# UNITED STATES PATENT AND TRADEMARK OFFICE

APPLICATION NO.	FILING DATE	FIRST NAMED INVENTOR	ATTORNEY DOCKET NO.	CONFIRMATION NO.
10/800,294	03/12/2004	Bjorn Paulshus	7822-91660	8246

## Office Action Summary

## DETAILED ACTION

**Fig. 6d**

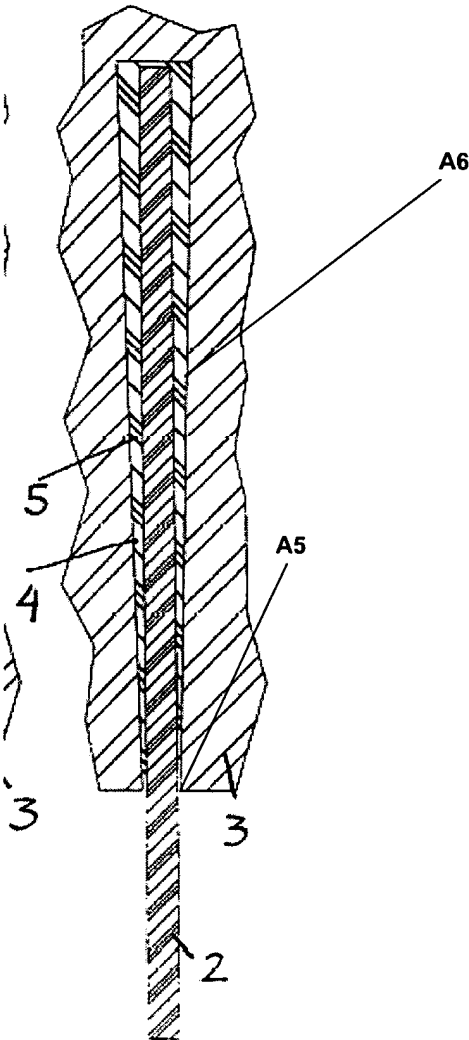
Regarding claim 22, Paulshus discloses, a termination of one end of a tension member **1** comprising multiple strands **2**. The strands **2** comprise fibers selected from the group consisting of carbon fibers, aramid fibers, and glass fibers (see page 3, lines 19-21) and the fibers having a lower shear force and durability than steel (see page 2, lines 12-15). A transitional zone (near reference **10** in Fig. 4) in the tension member **1** where the strands **2** are spread apart. At least one receiving body **3**. Each of the strands **2** in the transitional zone **10** are inserted into a narrow end **A5** of a respective conical hole **A6** in the at least one receiving body **3** and fixed in relation to the hole by a hardened mass **5**. However, Paulshus fails to disclose the wall of the conical hole **A6**

having a slip agent applied thereto such that the hardened mass **5** is prevented from adhering to the wall.

Regarding claim 26, the strands **2** are anchored in the holes **A6** in the receiving body **3**, and the holes **A6** are arranged in at least one ring around a center of the receiving body **3**. Note that Figure 4 shows several holes around a center of the receiving body **3**.

Regarding claim 27, the holes **A6** taper inward in a direction towards the tension member **1**.

Regarding claim 33, the holes **A6** comprise an increasing cross section in the direction away from the tension member **1**.

regarding claim 28, the prior art of record does not disclose or suggest a termination of one end of a tension member comprising a first receiving body having a smaller diameter than the diameter of a ring formed by the holes in a second receiving body. See lines 4-5. The closest prior art, Paulshus, WO 98/39532, and Andrews, 3,778,869, do not include this feature and there is no suggestion to provided this modification because in Paulshus, the receiving body is made of one piece, see Figs. 1-3, and in Andrews, the diameter of the first receiving body is larger than the diameter of the ring formed by the holes 26.
